DHCD – Division of Building and Fire Regulation
2006 Code Change Cycle

COMPILATION DOCUMENT
(of all code changes received with staff evaluations)

**USBC – Virginia Construction Code
Code Change No. C-310.6(R602.3)**

**USBC – Virginia Construction Code
Code Change No. C-310.6(R602.10)**

Note: Front wall contains the garage opening.

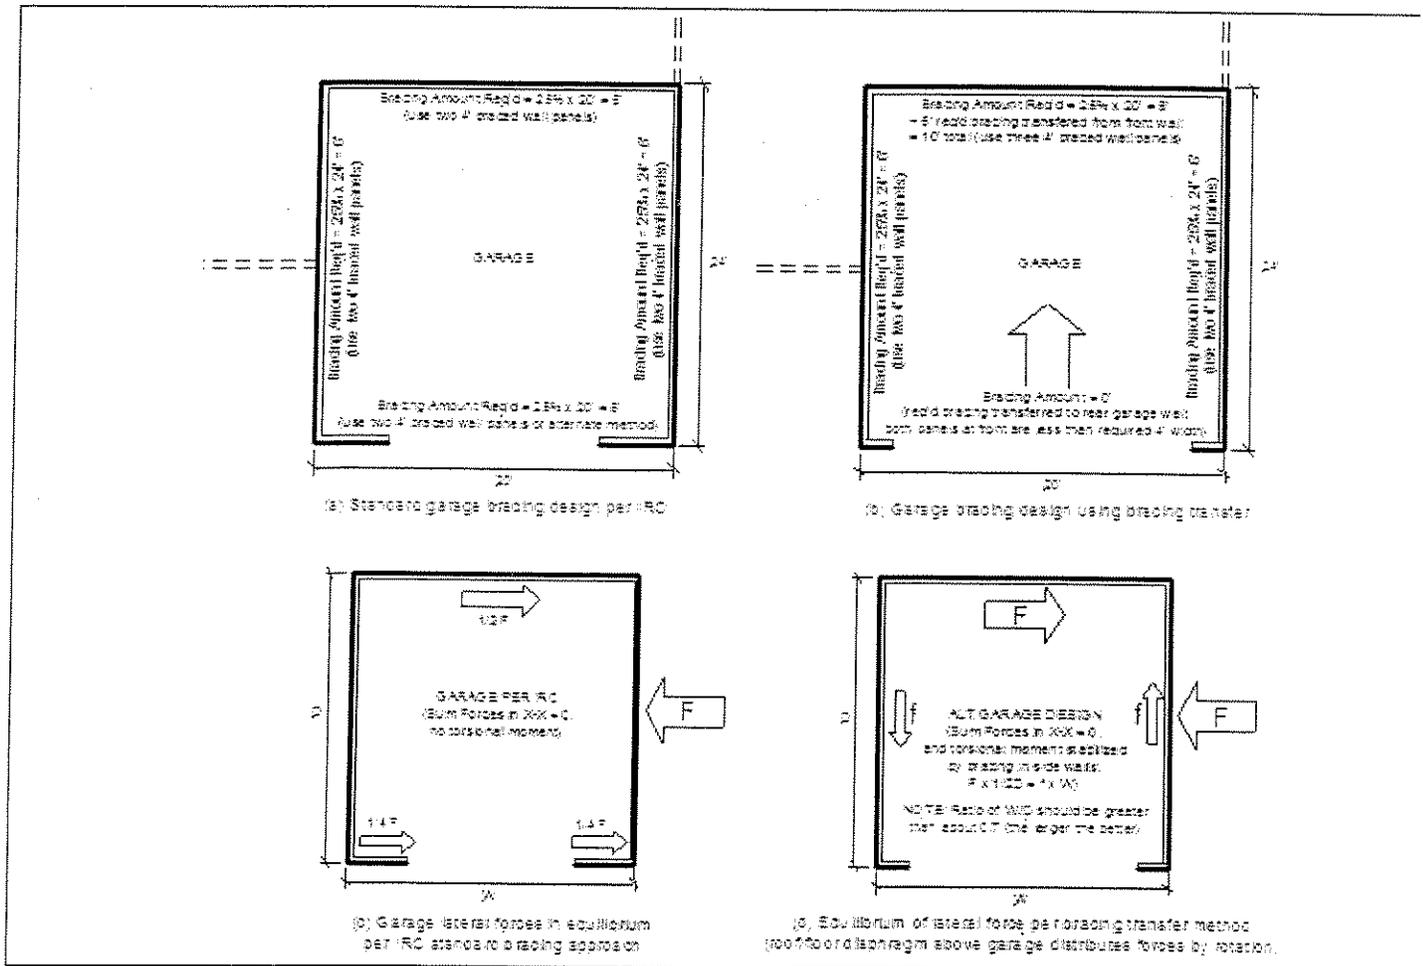
The second exception (see also the Figure below for example) provides a means of bracing a garage as a structural unit and does not require bracing on the garage opening wall line. This requires that the bracing amount is effectively doubled on the rear garage wall (opposite from the garage opening) to provide equivalent resistance to the direct shear load. Because this arrangement creates a torsional loading condition, the side walls must also be adequately braced to resist the torsional or twisting load that is created by way of a "force couple". This is simply achieved by bracing both side walls in compliance with bracing requirements of Section R602.10.1 and by limiting the plan aspect ratio of the garage (depth to width) as described in the proposal. This method is not new and has been in use for some time, but only by way of an engineered solution for individual buildings. Because of its simplicity and common need/use, this approach is more effectively addressed as a prescriptive solution in the code. This exception does not reduce bracing strength but achieves compliance through a different approach to building stability and lateral load analysis that more accurately distributes lateral load based on relative resistance of shear walls through floor and roof systems that act as rigid diaphragms based on whole building testing. The approach is explained and illustrated below.

Consider a garage of width, W , and Depth, D with a garage opening located in the width direction (see Figure below). The lateral load acting parallel to the garage opening and rear walls is resisted directly by wall bracing in the rear garage wall only (bracing value of narrow walls to either side of garage opening is considered negligible). This realistic loading condition creates a force couple or moment that attempts to rotate the garage opening wall about the rear wall that contains all of the shear resistance (bracing). The magnitude of this force couple is $V \times \frac{1}{2} D$ where V is the lateral load force (and is equivalent also to the amount of load resistance required in the way of wall bracing). While the direct shear force is resisted by the rear garage wall, the force couple is resisted by the side walls which produce a resisting force couple with a magnitude of $V_{sw} \times W$. Therefore, to maintain equilibrium of forces $V_{sw} \times W$ must equal or exceed $V \times \frac{1}{2} D$, where V_{sw} is the bracing resistance provide by the garage sidewalls. Setting these equal and solving for V_{sw} (required shear resistance in the side walls to resist the load force couple), the following design equation is determined to check equilibrium against the force couple or torsional moment created by this condition:

As shown above, when D/W is approximately 1.2 or less, this proposal that permits transfer of bracing from the garage opening wall to the rear garage wall (effectively doubling bracing amount in the rear garage wall) results in a structurally stable building or garage provided side walls area also braced in accordance with the code.
